## Product Change Notification / SYST-28KSUP099

ERRATA - USB72x6/USB7252 Silicon Errata and Data Sheet Clarification Document Revision

## USB72x6/USB7252 Silicon Errata and Data Sheet Clarification

**FIGURE 1: TOP MARKING SILICON REVISION INDICATION**

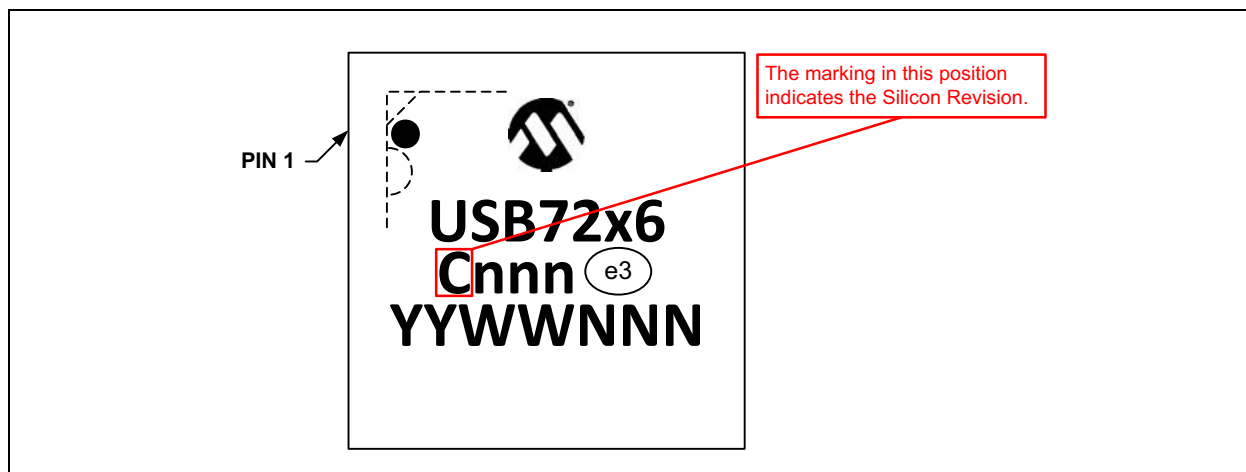
**Description of Change:** 1) All section: Updated document for C1 silicon.  
2) Table 1: Added C1 silicon revision to list.  
3) Figure 1: Updated figure to indicate where the silicon revision can be determined in the package top marking.  
4) Table 2: Added affected silicon revisions column.  
5) Modules 1., 2., 4., 5., 6: Updated Plan section to indicate the erratum is fixed in revision C1 silicon.  
6) Module 7: Added new module.  
7) Module 8: Added new module.

**Note:** [Figure 1](#) details the top markings of an example part and highlights the location of the silicon revision. Other top marking values may differ (lot codes, location of manufacture, and so on).

**FIGURE 2: TYPE-C DISCHARGE WORKAROUND FOR MODULE 3**

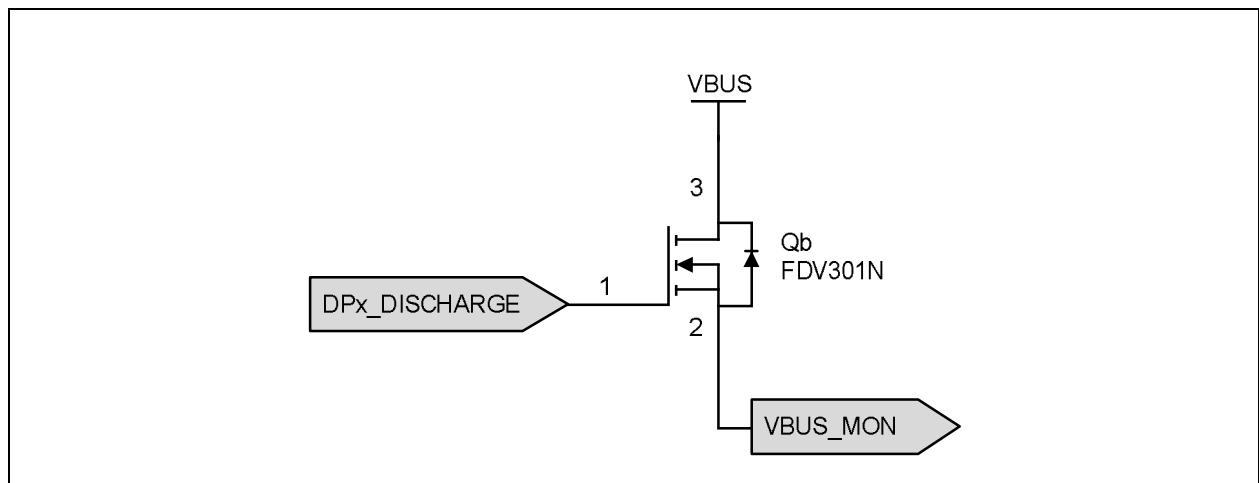
One requirement for USB-IF compliance certification of a system with an exposed Type-C port is the *Port Power On/Off* test. This test is part of the HUBCV suite of *Command Verification* tests for USB 2 devices. As part of this test, the hub must discharge VBUS, and then energize VBUS in response to CLEAR\_FEATURE and SET\_FEATURE commands from the test host.

Frequently, these ports will be implemented with electrolytic VBUS load capacitors, which retain a small residual charge that is released slowly compared to the timing of the discharge. In such cases, as energy is released from the capacitor the voltage can drift upward slightly after the discharge, which can cross the VBUS\_DET threshold for detecting VBUS high. In the sequence of the Port Power On/Off test, this can inhibit subsequent turning on of VBUS in response to commands from the test host and the test fails.

Type C ports that have a large electrolytic capacitor may require this workaround to pass the HUBCV Port Power On/Off test.

In reference designs for USB7216 and USB7252 devices, an N-channel MOSFET with a  $V_{GS}$  less than 1.0V is connected between VBUS and VBUS\_MON, with gate control from the DISCHARGE signal. This additional component creates an additional current path as the discharge is monitored by VBUS\_MON, which biases VBUS\_MON higher. This results in discharge to a lower voltage than what is otherwise achieved, and compensates for any residual energy that the capacitor releases after the discharge. At times other than the discharge, the MOSFET is turned off and does not influence VBUS.

No components of the reference design need to be removed; only the MOSFET is added.
